## GODDARD SCHOOL ANNEX JSP22-59

Consideration of Preliminary Site Plan and Stormwater Management Plan approval at the request of Doeting Education Co and the Goddard School of Novi for an addition to the existing Goddard School. The subject property is comprised of two parcels planned to be combined. The first parcel, which contains the existing Goddard School, is 2.04 acres in size. The second parcel is 2.29 acres in size. The subject property is located on the north side of Grand River Avenue and south side of 12 Mile Road, east of Wixom Road, and it is in the B-3 General Business District. The applicant is proposing to add on to the existing Goddard School to accommodate an anticipated increase in enrollment from 154 to 274.

## **MOTION SHEET**

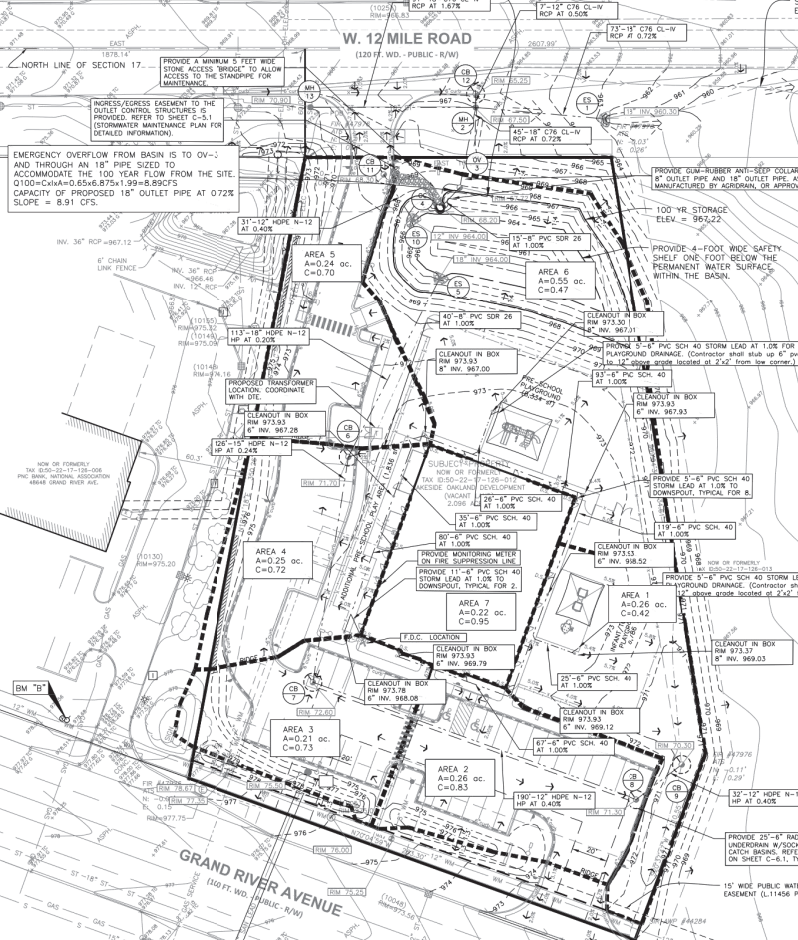
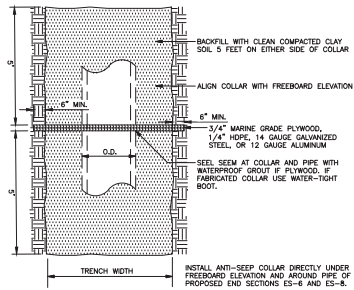
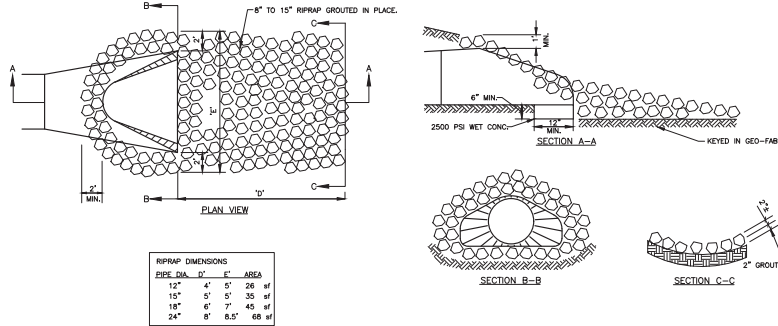
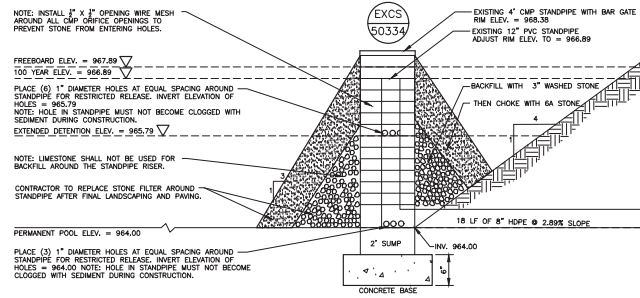
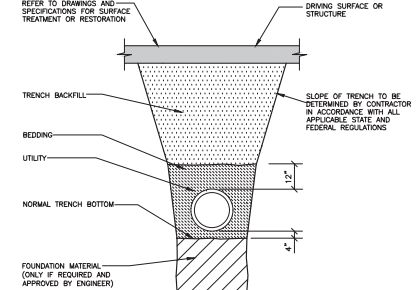
6. Provide the cross-section of the detention basin, and include all elevations for the standpipe, the free board elevation...etc. (revise the outlet control structure details on sheet C-9.3 to reflect the proposed items)

**The detail on sheet C-9.2 has been updated to show the freeboard elevation.**
